FOURSQUARE AT STERLING RANCH EAST FILING NO. 1 GRADING AND EROSION CONTROL PLAN			
DESIGNED BY	DLG	SCALE	DATE 11-30-22
DRAWN BY	DLG	(H) 1" =	SHEET 2 OF 27
CHECKED BY	(V) 1" =	JOB NO.	1183.23

FOURSQUARE AT STERLING RANCH EAST
FILING NO. 1
GRADING AND EROSION CONTROL PLAN

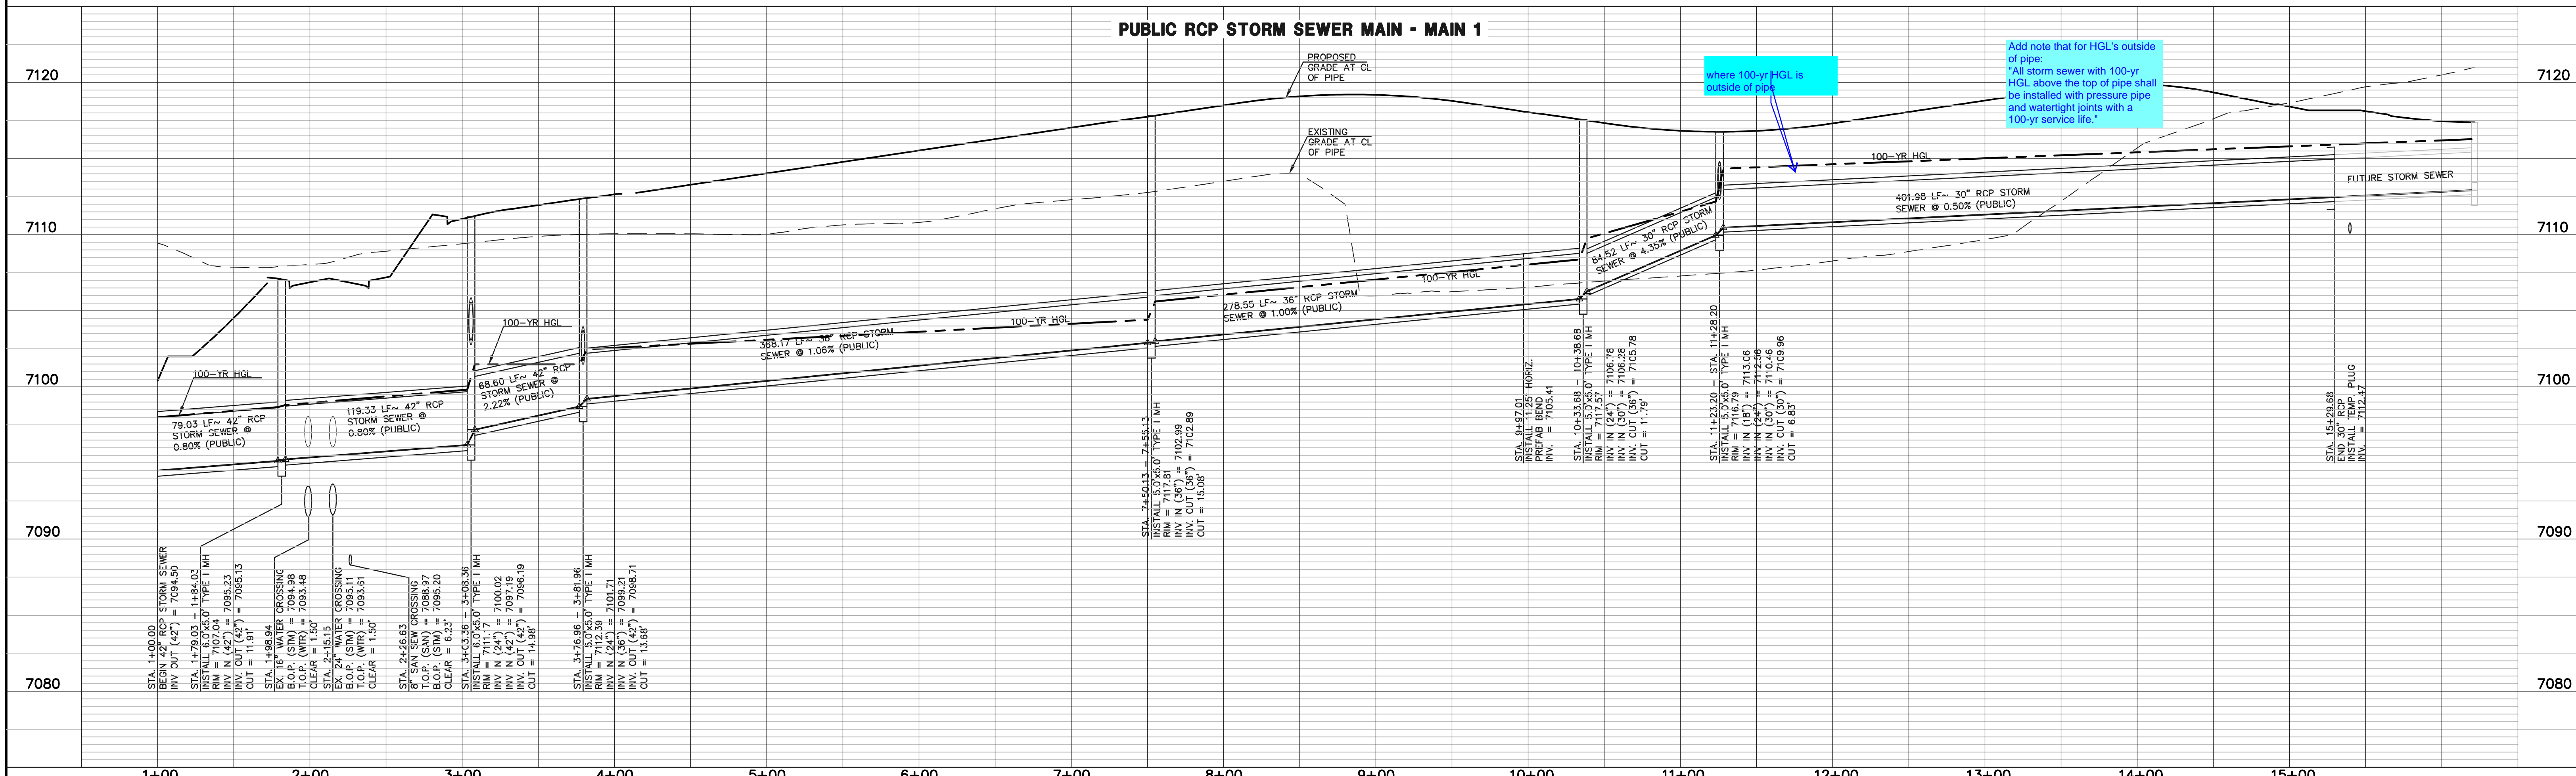
Provide details or notes for attachment of sidewalk to inlets to meet ADA requirements

Full review of storm system will be completed with next submittal after drainage flows and storm system have been revised based on comments provided on FDR with project SF2237.

where 100-yr HGL is outside of pipe

Add note that for HGL's outside of pipe: "All storm sewer with 100-yr HGL above the top of pipe shall be installed with pressure pipe and watertight joints with a 100-yr service life."

FOURSQUARE AT STERLING RANCH EAST
FILE NO. 1
PRIVATE PERMANENT CONTROL MEASURE
PRIVATE EXTENDED DETENTION BASIN PLAN SET

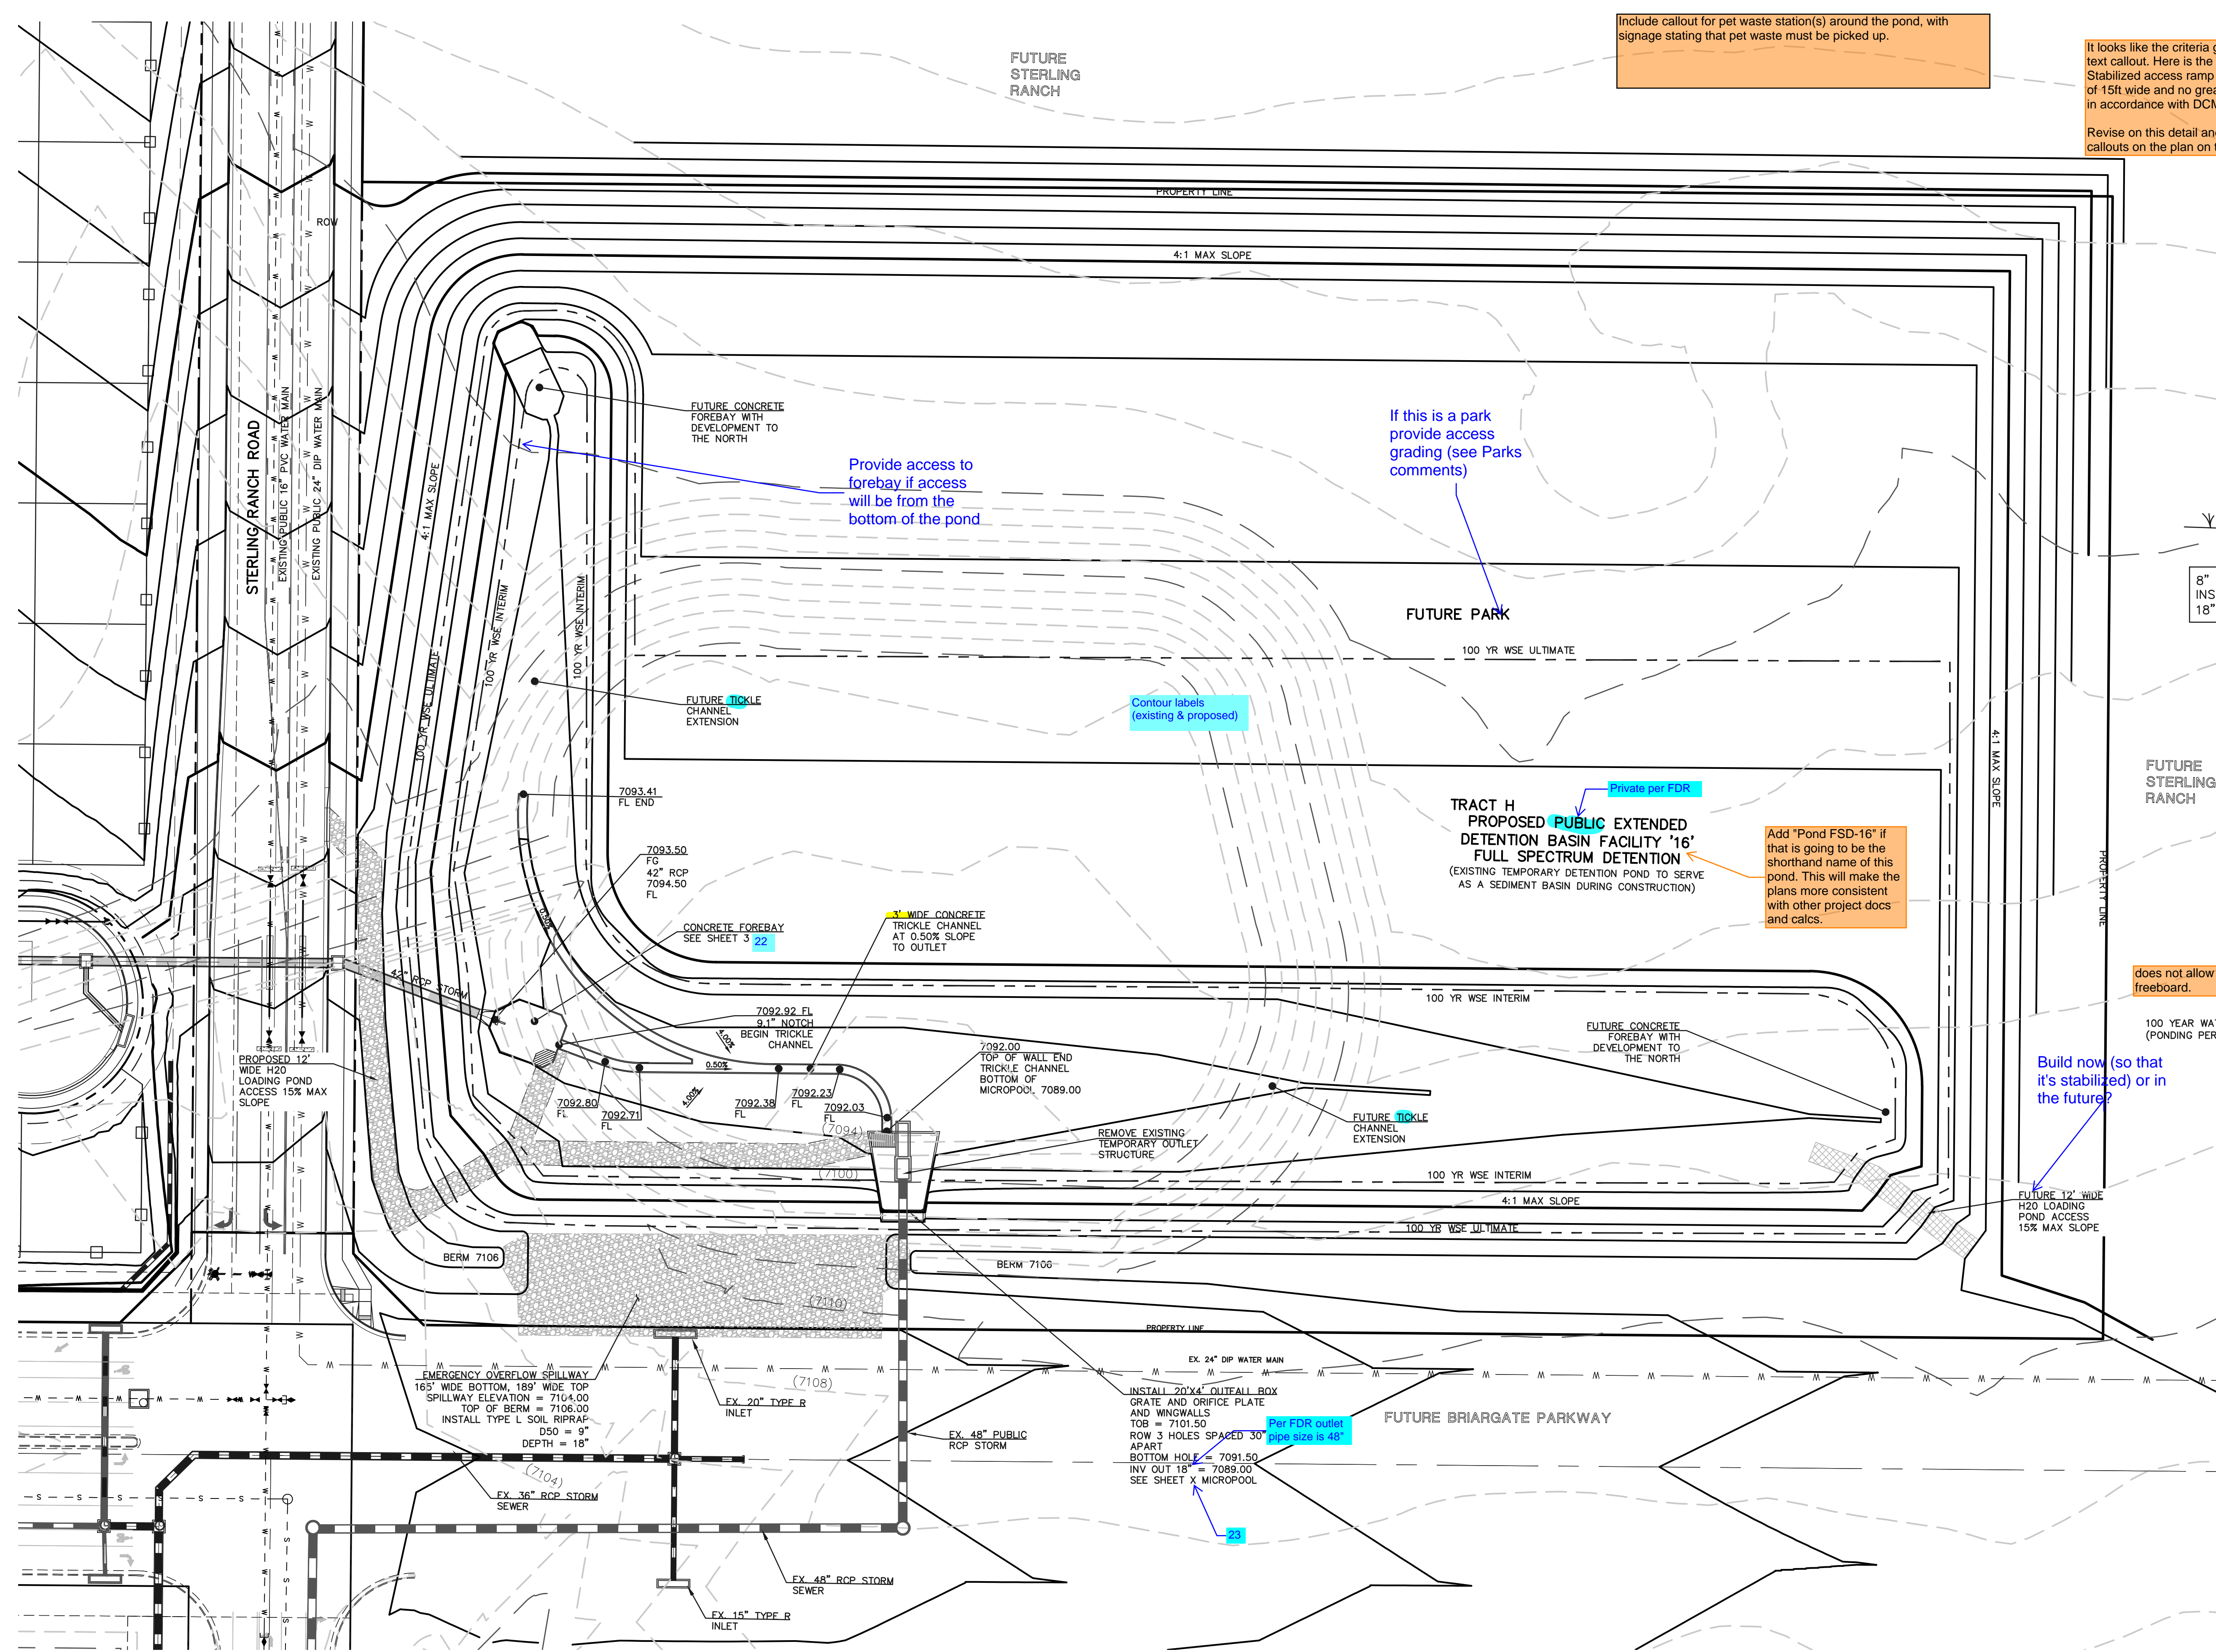
It looks like the criteria got mixed up in this text callout. Here is the correct criteria: Stabilized access ramp shall be a minimum of 15ft wide and no greater than 12% slope, in accordance with DCMv1, Chap 11.2.2. Revise on this detail and on the two text callouts on the plan on this sheet.

Trickle channel width doesn't match note on plan. Per comments on FDR, provide calculation determining width of channel. Update notes accordingly!

The plan to the left states that this is soil riprap. But this detail appears to show topsoil on top of the soil riprap? At what depth? Clarify.

shown as 7103.24 on sheet 23. Revise for consistency. Also label that this is for the Ultimate condition.

No other spillway detail provided. Do you mean "see plan this sheet"?

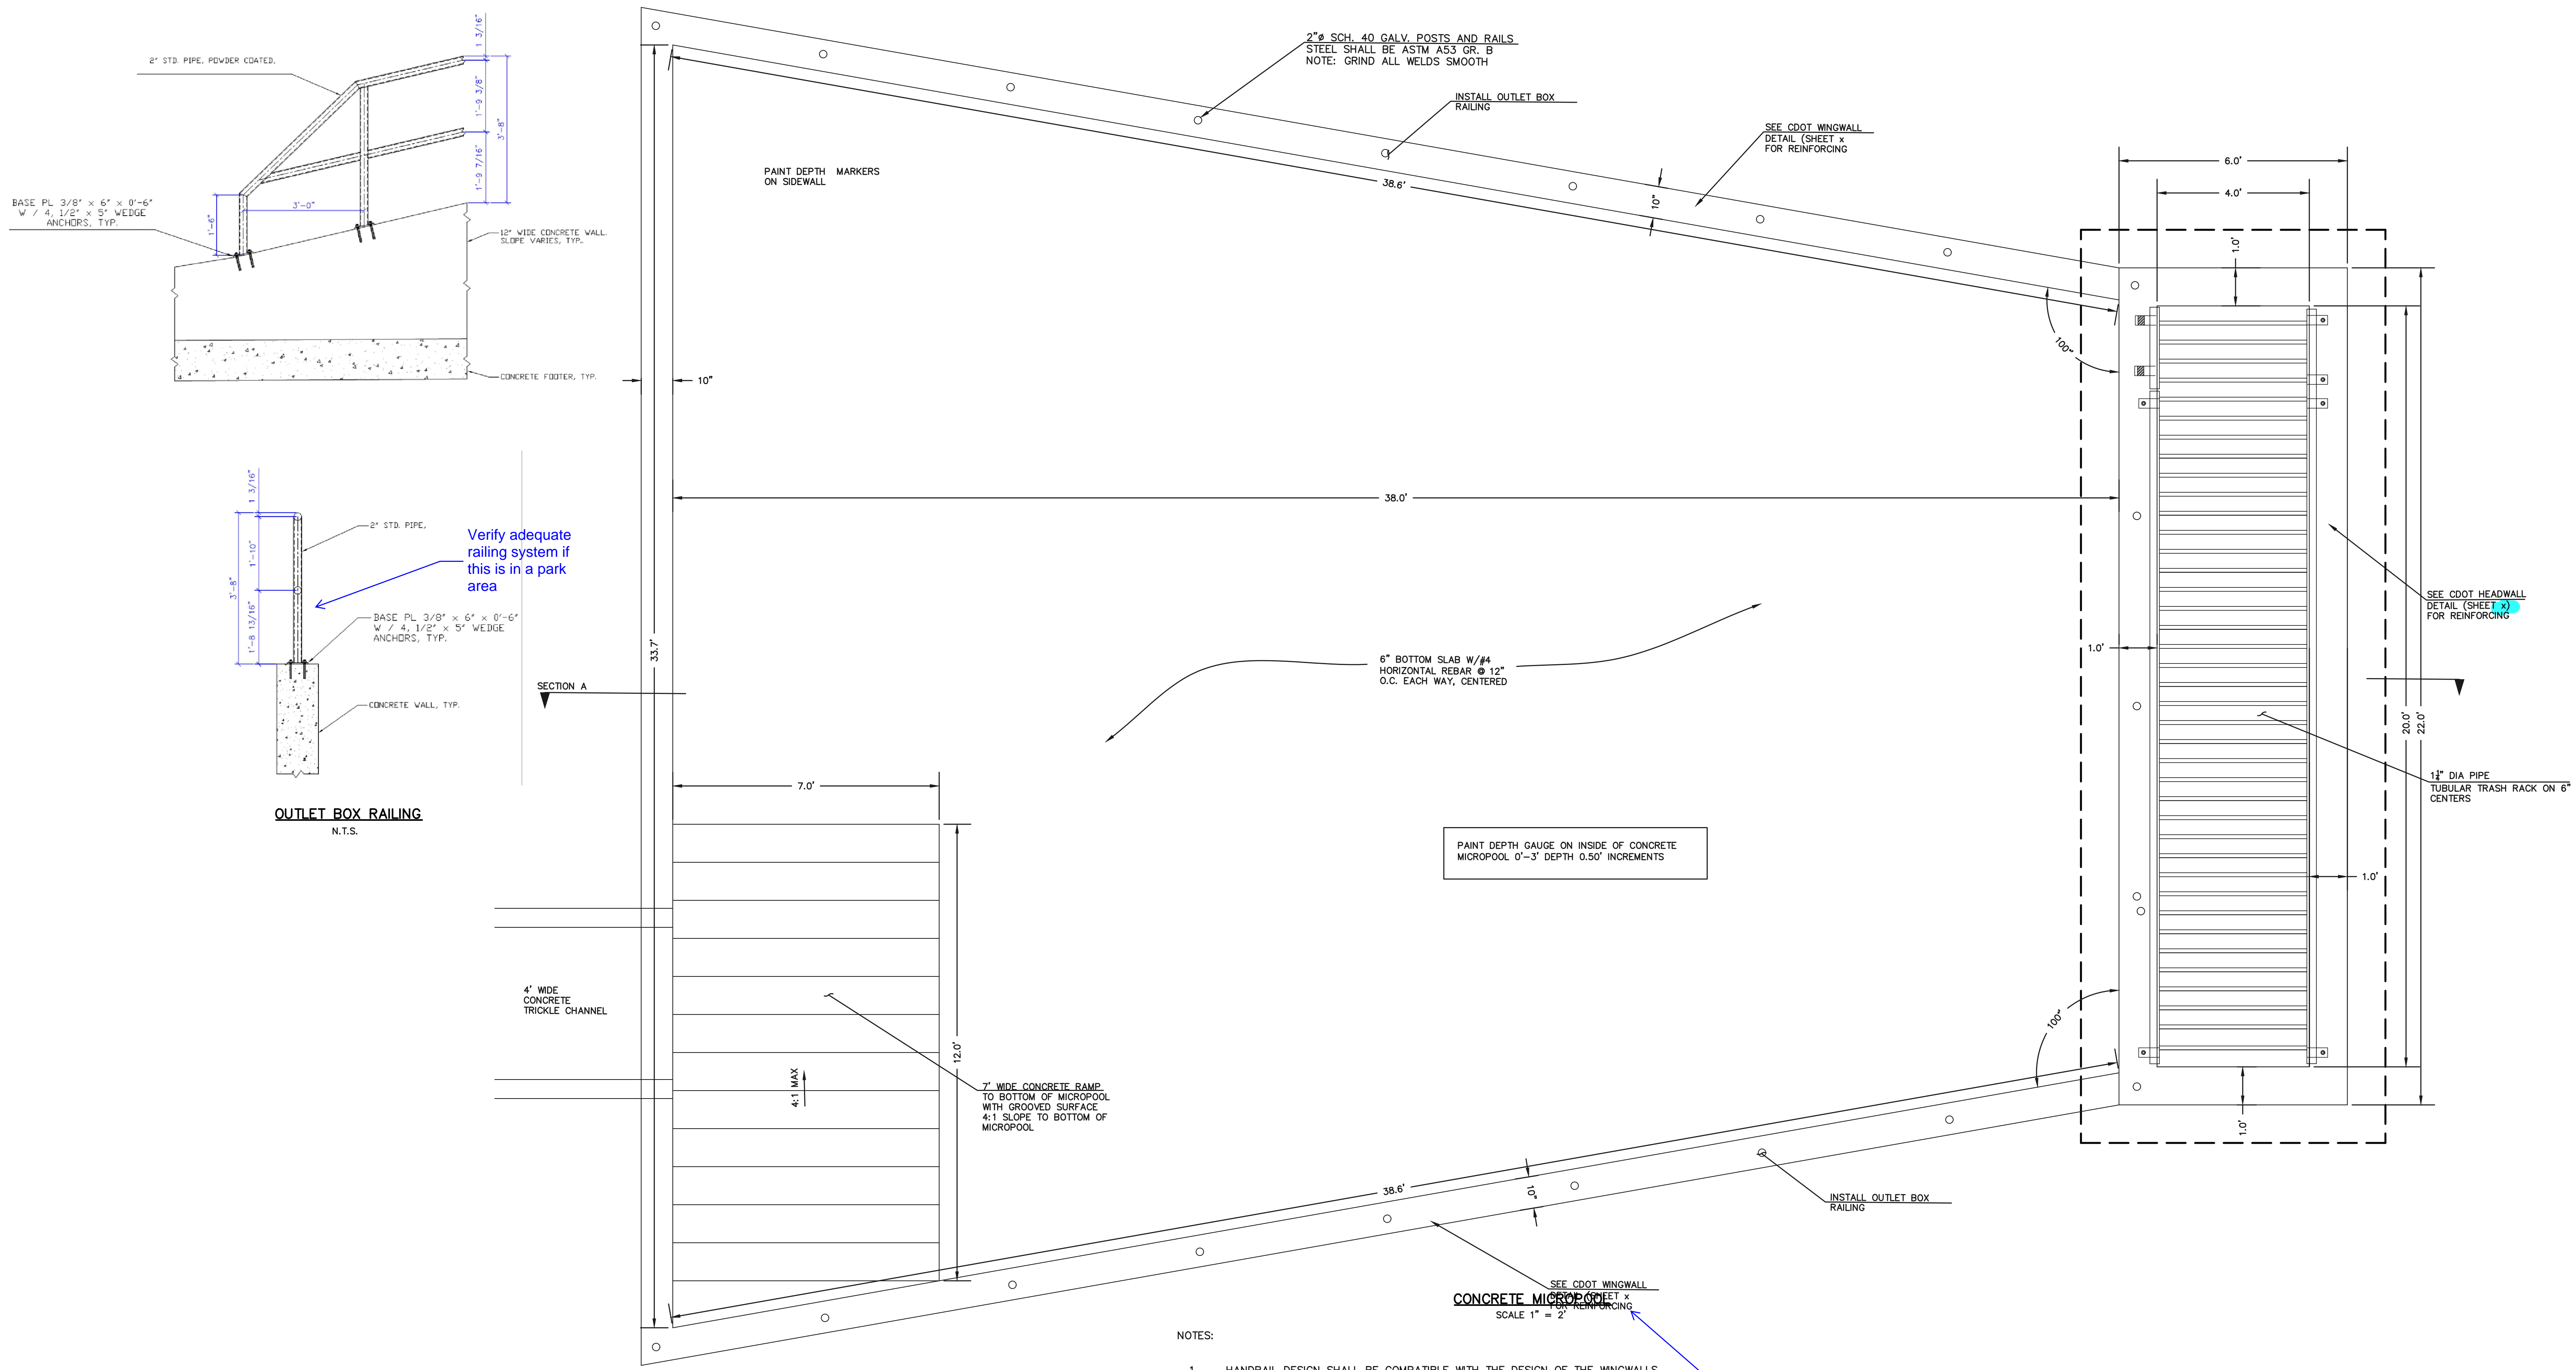
Verify adequate railing system if this is in a park area
